PROJECT
JEDDAH OPERA HOUSE

TITLE:
OPERA BUILDING
VERTICAL TRANSPORTATION
PART 001
PLANS - LIFT SHAFT (L05)

DRAWING No: JOH-OTS-S5-01-056-001-ZZ-SD-VT-011010 REV: S01

SCEC – K&A Reviewed
Code B – Approved with Comments
(Do not Resubmit)

1 Hoist Way Plan At "B2" Floor - ELEV-L5

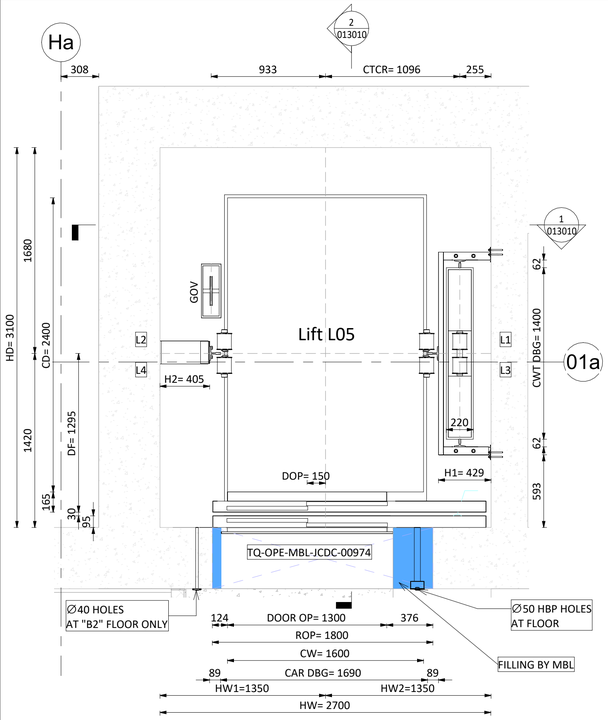
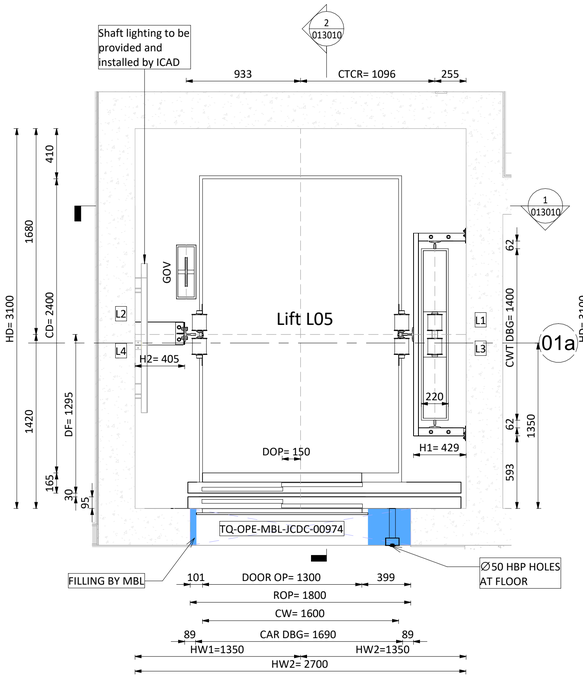
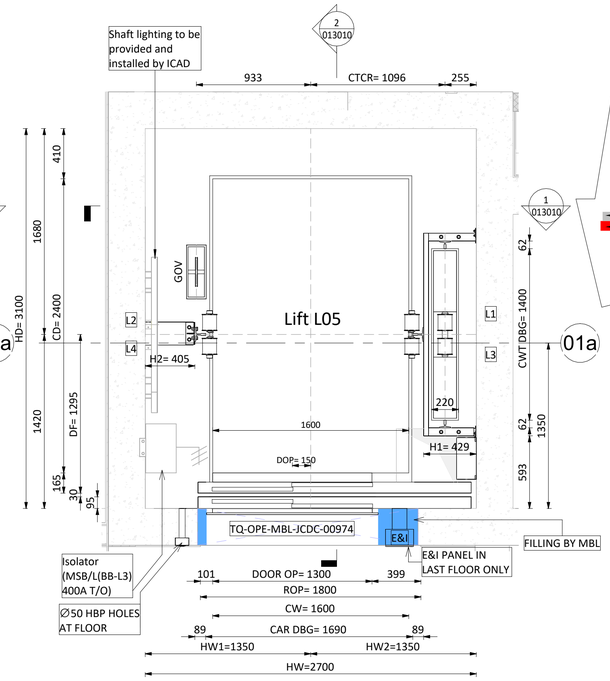
the Note provided on the drawing is rejected and the word (by client)shall be replaces to (by main contractor):

1 Door Elevation At "B2" Floor - ELEV-L5

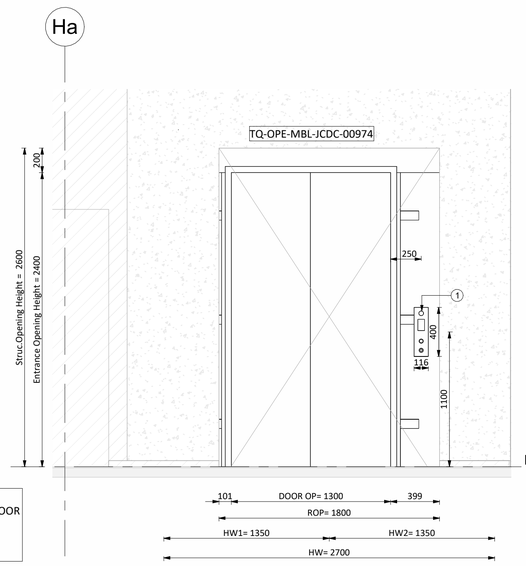
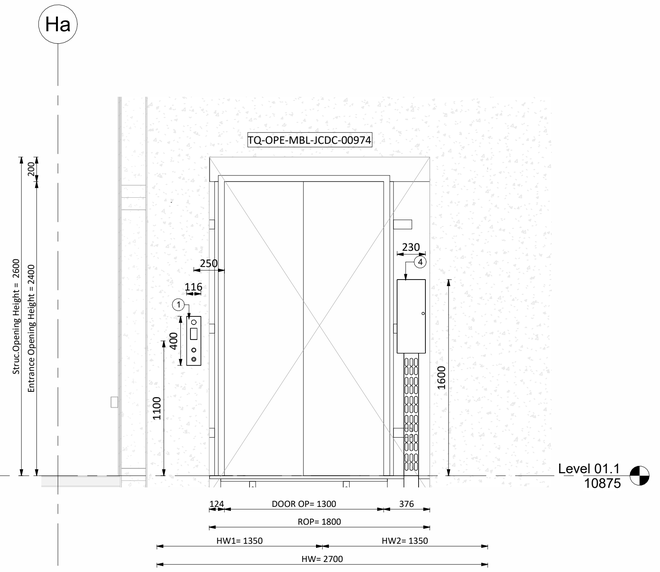
call button centerline height of 1100 mm is ok subject that the installation remains fully compliant with EN 81-70 and the applicable accessibility requirements
